From: Ann Homan
Sent: 27/01/2025 11:24:22 AM
To: Council Northernbeaches Mailbox
Subject: TRIMMED: Re: Application Number: DA2024/1693 -
Attachments: DA20241693 Submission to Council 32 Nareen Parade, North Narrabeen.pdf;

We are writing to you with a submission of our concerns in regards to the property 32 Nareen Parade, North Narrabeen NSW 2101. **Application Number: DA2024/1693**

Photo 4

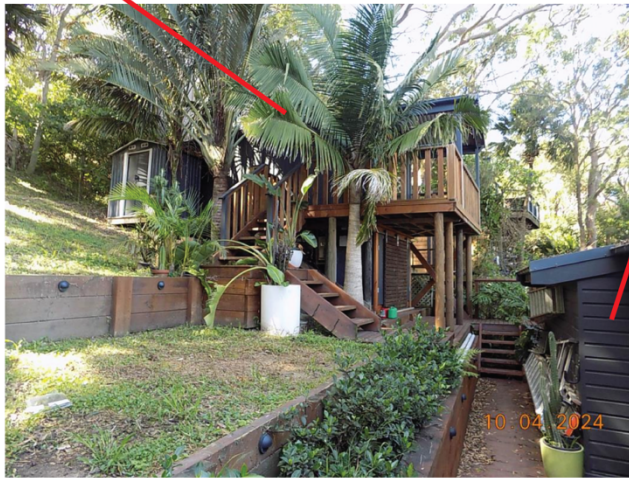
My issue with this development is that No. 32 Nareen Parade already has a Granny Flat situated on the property. This dwelling includes a bathroom, toilet, kitchen.

This structure is missing from all of the plans that were submitted to the council.

Specifically, Photo 4, which is the Granny Flat itself. And Photo 7 which shows the Granny Flat in relation to the main dwelling.
